AMENDMENT NO. 2 MARCH 2002
TO
IS 875 (PART 3) : 1987 CODE OF PRACTICE FOR DESIGN LOADS (OTHER THAN EARTHQUAKE) FOR BUILDINGS AND STRUCTURES
PART 3 WIND LOADS

(Second Revision)

13A General Notations

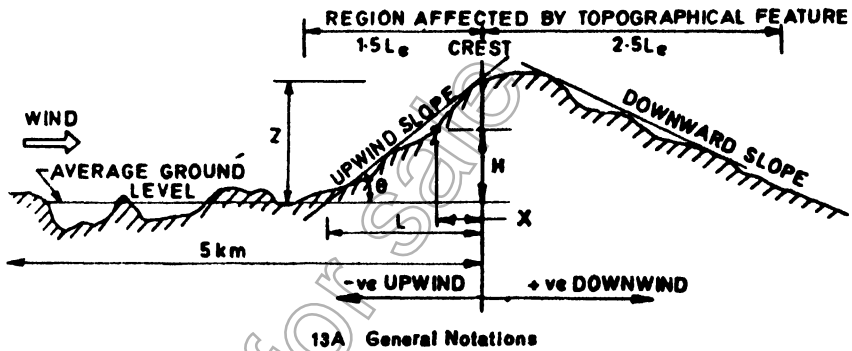
(*Page* 56, *Fig.* 13A) — Substitute the following figure for the existing:
